PARTS & SERVICE NEWS

REF NO.	AA02212
DATE	October 2, 2002

SUBJECT: RETRACTABLE SEAT BELT ASSEMBLY FAILURE

PURPOSE: To introduce a new and improved design seat belt that is less likely than earlier equipment to fail by getting stuck in the retractor mechanism.

Figure 1

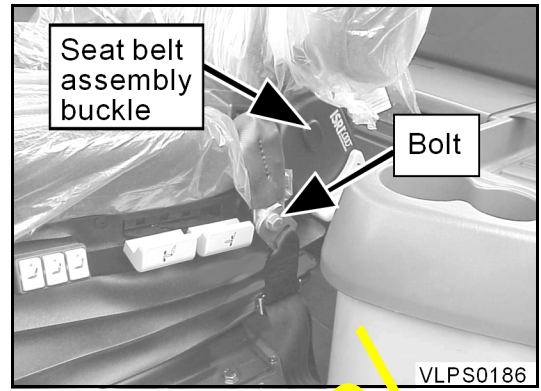
1. Remove the existing seat belt assembly mounting bolts at the right and left sides of the operator's seat (Figure 1).
2. Remove the seat belt assembly.

1. Install the new seat belt assembly, oriented as shown in Figure 1 and Figure 2.
2. Secure with the bolts provided in the seat belt assembly kit.
3. Tighten the bolts to 10 - 12.5 Nm (7.38-9.22 lbf ft).
